## ADDENDUM NO. 2

**PROJECT NAME:** Wick Alumni Center Life Safety & HVAC Improvements  
**UNL PROJECT NUMBER:** C120P021  
**BID INVITATION NUMBER:** 2222-13-7200

**CONSULTANT:** Farris Engineering  
**ADDRESS:** 818 P Street, Suite 100

**DATE OF ISSUANCE:** September 11, 2013  
**DATE OF BID OPENING:** September 18, 2013

SHEET NO  
**M1-3**

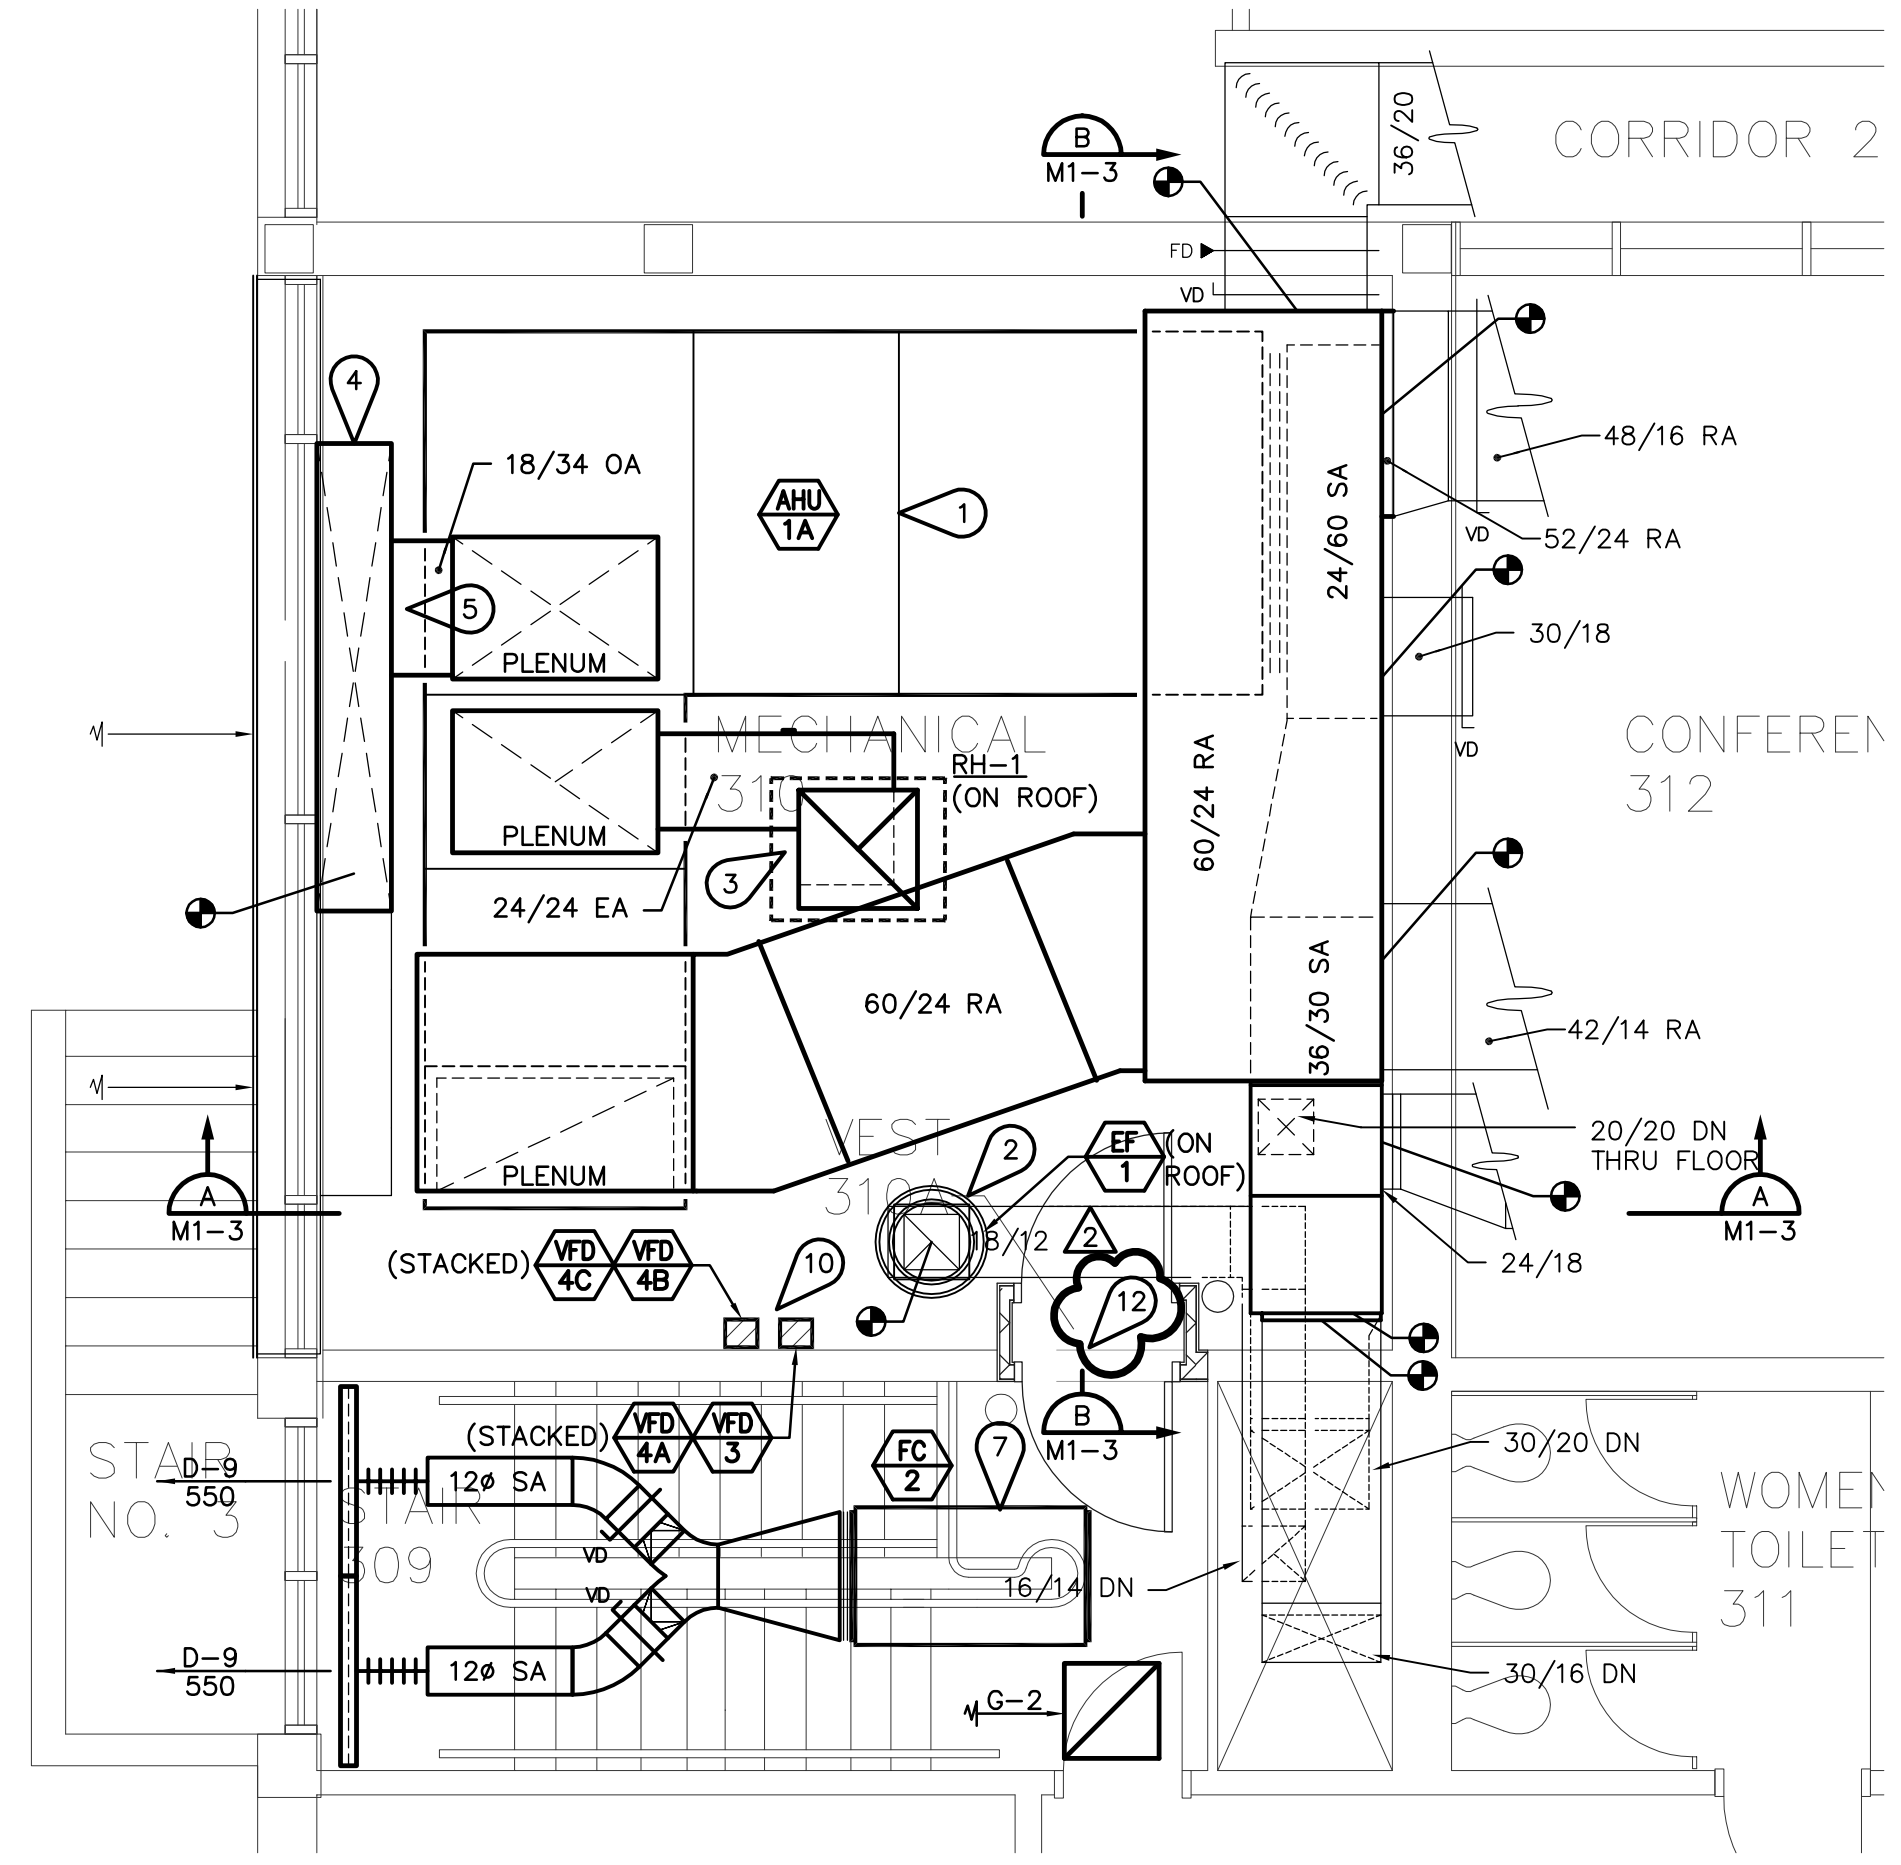
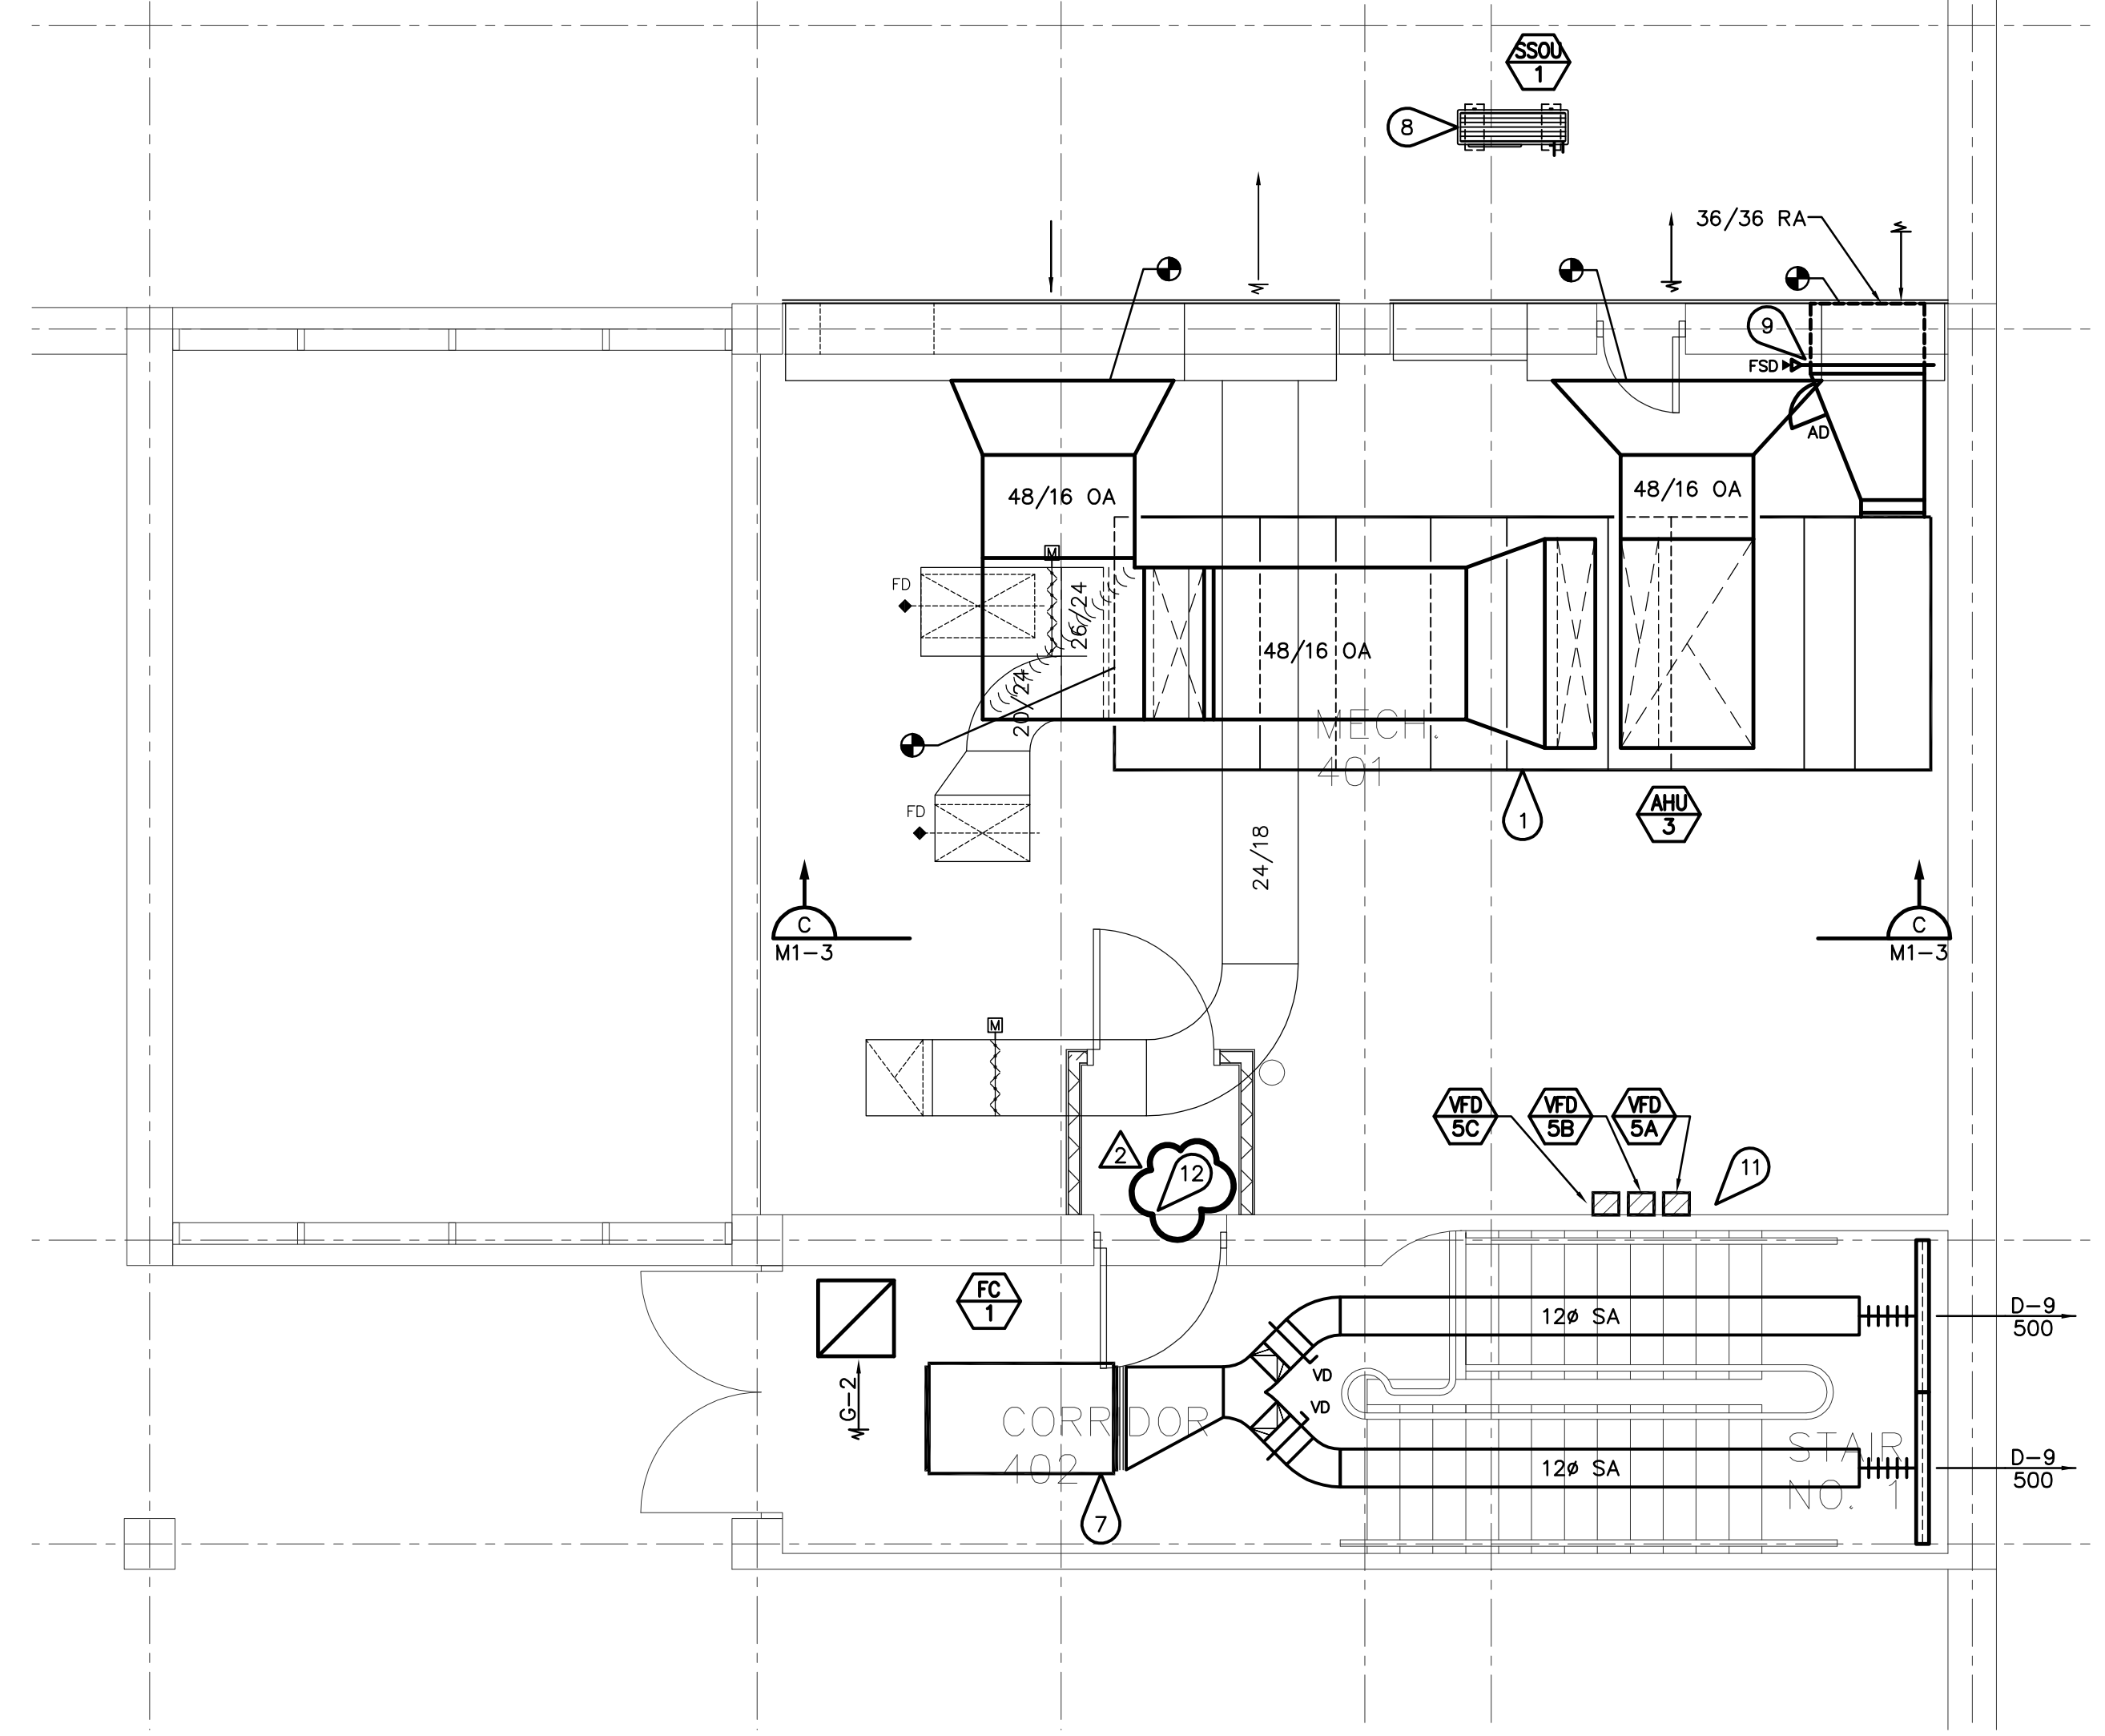
1. This sheet has been reissued in its entirety as a part of Addendum No.2.
2. Mechanical Keynote #12 has been added.

- 12 CONTRACTOR SHALL VERIFY ACCESS INTO ROOM FOR NEW AIR HANDLING UNIT AND PROVIDE UNIT CAPABLE OF FITTING THROUGH DOOR IN SECTIONS FOR FIELD ASSEMBLY. SEE AIR HANDLING UNIT SCHEDULE SHEET M6-2.
